Reviewed for code compliance

City of Parker. This year as in years past, Costco is planning to do a large live plant and flower display in our vestibule area. This seasonal promotion will run the duration of about 6 weeks. In an effort to prevent theft and conceal the merchandise, we will assemble a fence of 154 feet that will be placed 7 feet away from the outside wall of our building. With the fence assembled, an 8 foot walkway will still be available for pedestrians.

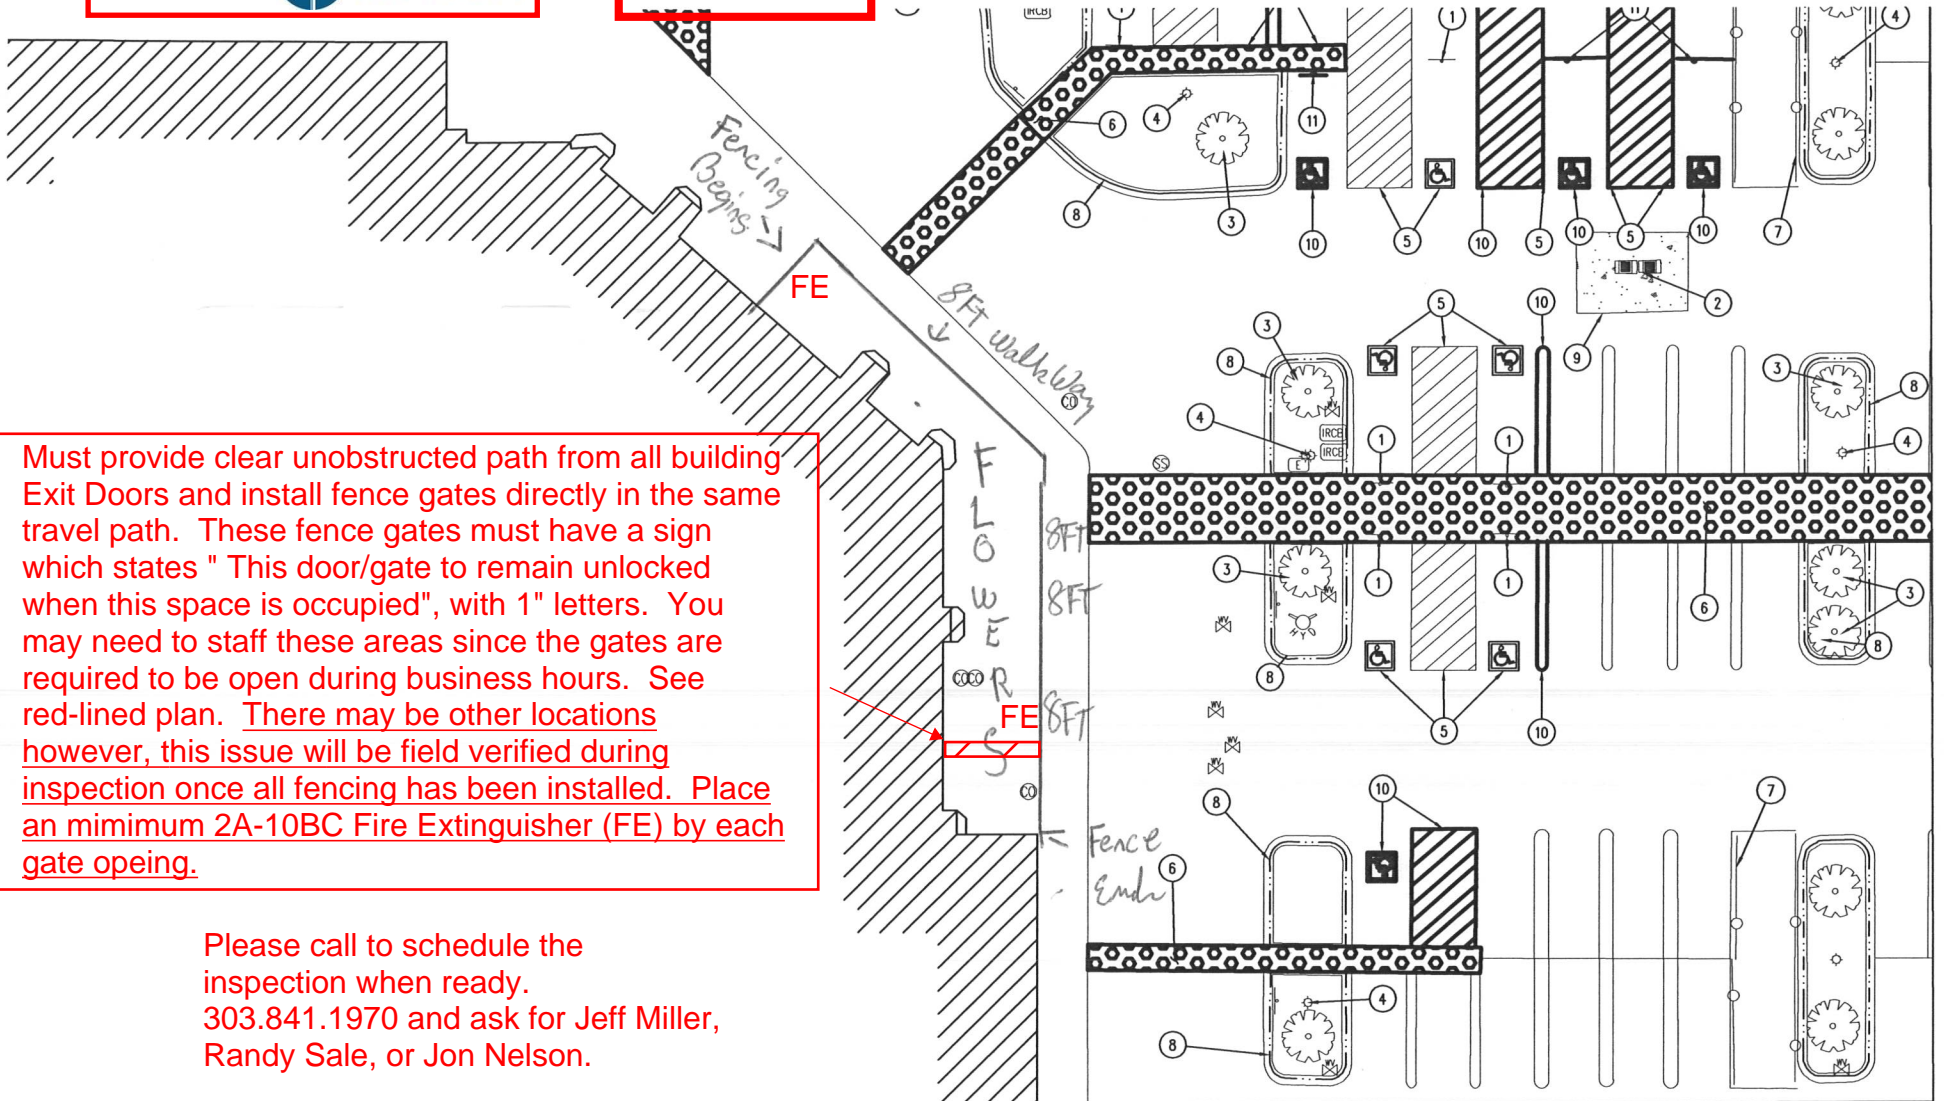
Must provide clear unobstructed path from all building Exit Doors and install fence gates directly in the same travel path. These fence gates must have a sign which states " This door/gate to remain unlocked when this space is occupied", with 1" letters. You may need to staff these areas since the gates are required to be open during business hours. See red-lined plan. There may be other locations however, this issue will be field verified during inspection once all fencing has been installed. Place an minimum 2A-10BC Fire Extinguisher (FE) by each gate opening.
